SAVANNAH ZONING BOARD OF APPEALS

STAFF REPORT

PETITIONER: Jared & Jessica Lott
FILE NO: 25-005775-ZBA
ADDRESS: 6 Chipper Cir
DATE: January 22, 2026

Proposed ADU Layout

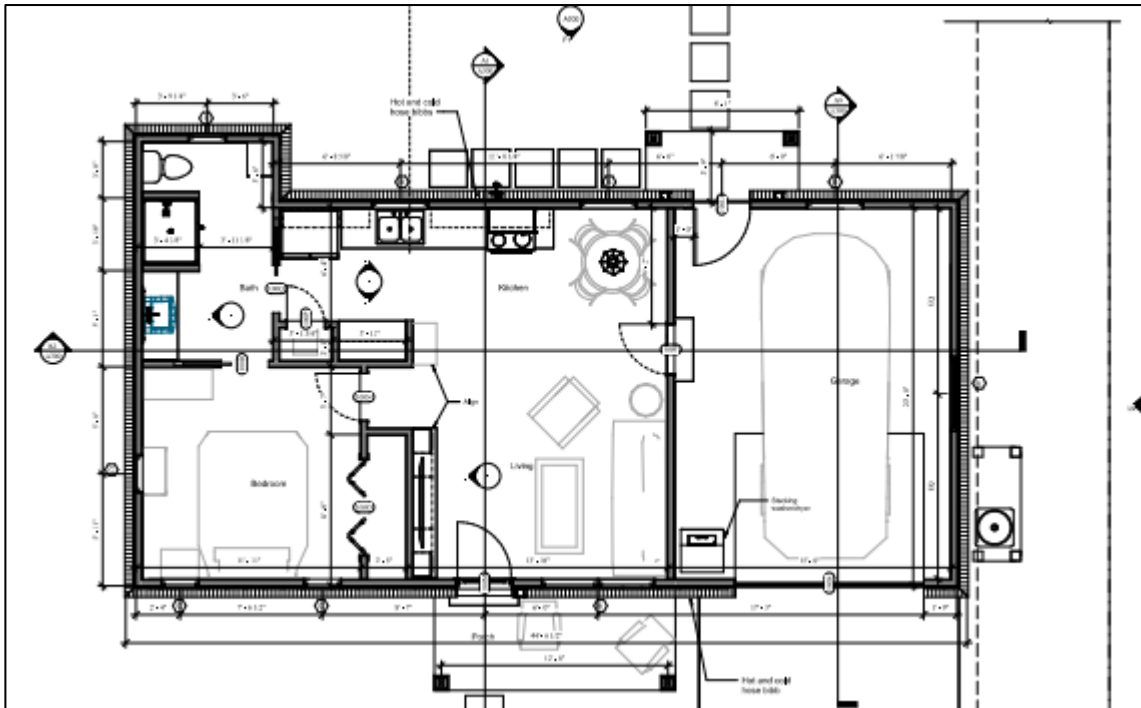
5. [Section 8.7.4.d.i](#) of the Zoning Ordinance requires a maximum of 700 square feet for the building footprint of an ADU. While the Petitioner does not exceed the 40% in relation to the primary dwelling requirement, their proposed ADU is 982 square feet. This exceeds the maximum by 282 square feet. It does not exceed the 40% portion of the rule, as 40% of the principal dwelling would be 1,035 square feet.

6. [Section 4.3.3.a.v](#) of the Zoning Ordinance requires driveways to have a setback of at least 3 feet from the side property lines. The Petitioner is proposing to reduce this setback to 1 foot from the east side (interior) yard property line at one point. A driveway to the primary dwelling currently exists, and the Petitioner proposes to put a concrete pad and driving pavers to extend the driveway for off-street parking access at the ADU. Most of the driveway meets the 3-foot requirement; just a minor portion of it requires a variance.

MPC Comment: The variances are not required to make use of the subject property. The Petitioner can reasonably scale back the building footprint to 700 square feet.

MPC Staff recommends **denial** of the following two variances in association with the construction of an accessory dwelling unit (ADU) in the RSF-10 zoning district:

1. To allow the ADU to exceed the 700 square foot building footprint maximum by 282 square feet;
2. To reduce the setback of a residential driveway from 3 feet to 1 foot.
